Rampion 2 Wind Farm Category 7: Other Documents Evidence Plan (Part 3 of 11) Date: August 2023 Revision A

Document Reference: 7.21 Pursuant to: APFP Regulation 5 (2) (q) Ecodoc number: 004866615-01

Rampion 2 Offshore Wind Farm (OWF)

MMO Response to Underwater Noise ETG Minutes, Underwater Noise Mitigation Technical Note and Additional Noise Monitoring Technical Note.

Figure 1 Contour boundaries, utilising 147 dB SELss (unweighted) model outputs with zero overlap target to the boundary of Kingmere and Beachy Head West MCZ, for worst case monopiles with various mitigations

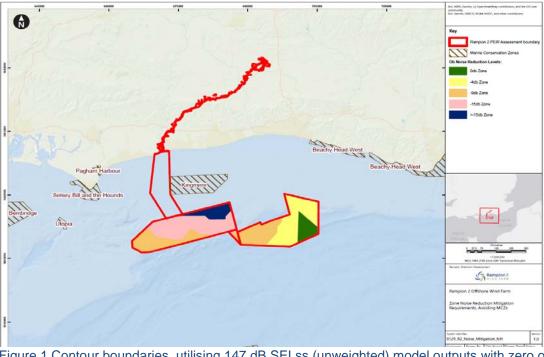
- 15. The proposed zoning (see Figure 1 below, taken from the technical note) is sensitive to/reliant on modelling and the noise threshold, both of which are subject to significant uncertainties. One small change would alter the proposed zoning. Therefore, caution should be applied if suggesting part of the site does not need mitigation.

- 23. Figure 1 presents contour boundaries using combined mitigation options for dB reduction modelled based on the 147 dB SELss (unweighted) model outputs to obtain no overlap with MPAs. While it is understood this is to provide context on the 'zones' or areas of the Rampion 2 array that would require different noise reductions or combinations of the mitigation to achieve this, it is difficult to infer the extent of the individual mitigated contours and how these boundaries alter when changes are made to the modelled inputs.

- 24. Though it is recognised that some of these are provided individually within the modelling technical note, they are not provided in combination, please provide this, however it is recommend this is done after a behavioural metric has been agreed so these mitigation options can be fully reviewed in depth.

Figure 2 SELss noise modelling contours for piling at the NW location, monopile, maximum energy

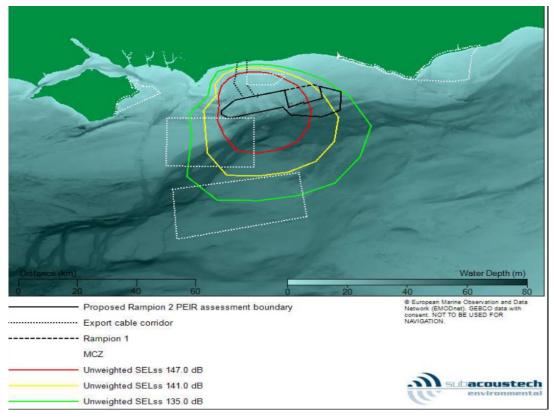
- 18. The worst case (unmitigated) noise contours for all three thresholds are provided in Figures 4 to 6. In Figure 4 (Figure 2 below for reference), the noise contours for the NW location show a clear (and complete) overlap with the Kingmere MCZ (even based on the least precautionary threshold of 147 dB). Therefore, it is evident that appropriate mitigation (in terms of noise abatement) will be required to reduce the noise at source to acceptable levels (notwithstanding the uncertainties surrounding behaviour and what is considered to be an acceptable noise level/threshold).
